Subject: CD PLAYER DISPLAY CONCERNS	Bulletin No: 09-032/14
	Last Issued: 07/14/2014

2014 Mazda3 vehicles (with MAZDA CONNECT and CD player) with VINS lower than JM1BM**** ** 154022 (produced before December 01, 2013)

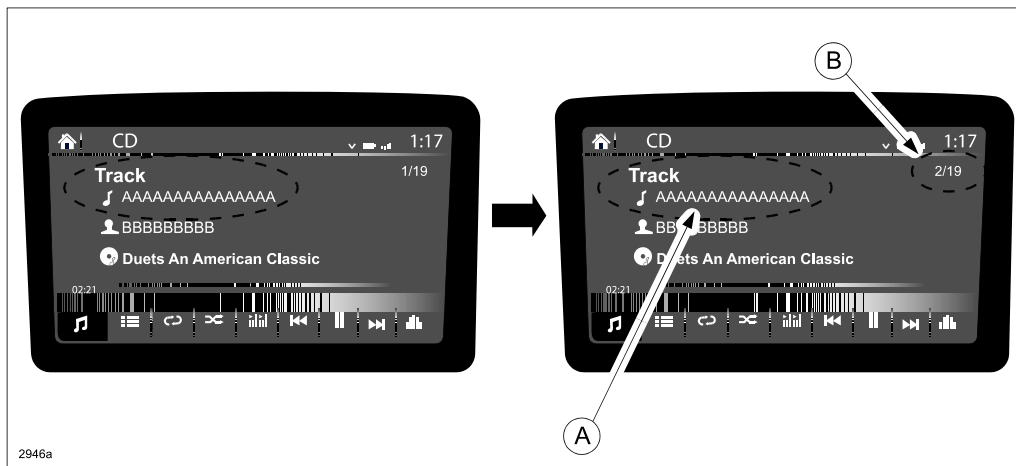
Symptom 1: The song title on the CD display (A) does not change when it goes to the next song. However, the track number (B) changes

Symptom 2: The track list does not open after inserting the CD, but the “Disc loading” appears on the display.

This is caused by improper software of the CD player. The software of CD player has now been changed to correct this issue.

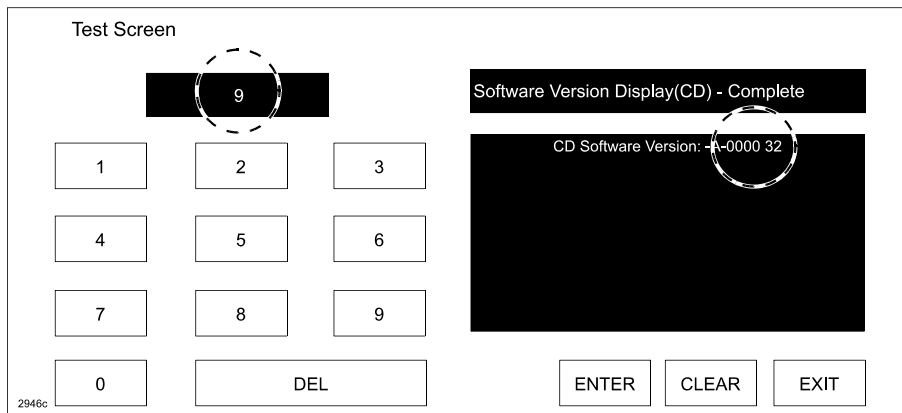
1. Verify customer concern.
2. Check the software version.
 - a. Press the three buttons (Music (A) + Favorites (B) + Volume Mute(C)) on the commander switch at the same time for 2-5 seconds and the Diagnostic Test Screen will appear.
